1 Products affected

2 Type of change

478X					0118.2048	
Creation date:	Created by:	Release date:	Released by:	Notification No.	Index	Page
13.09.2010 11:04:41	SHA	22.03.2011	SHA	22159	a	1 von 1

3 Detailed description of change

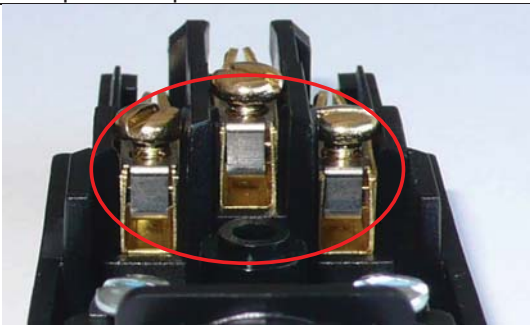
OLD: screw presses directly on the contact	NEW: pressure plate between screw and contact

Wiring through a screw. The flexible wire has tendencies to move on one side.	Wiring through a pressure plate. When the screw gets torqued, the pressure plate is pressing on the flexible wire.

According to the change of the standard EN/IEC60320-1 Amd.1, the parts are new checked with a withdrawal force of 30N. Before it was 20N. Otherwise the Standard EN/IEC60320-1 Amd.1 is not fulfilled.
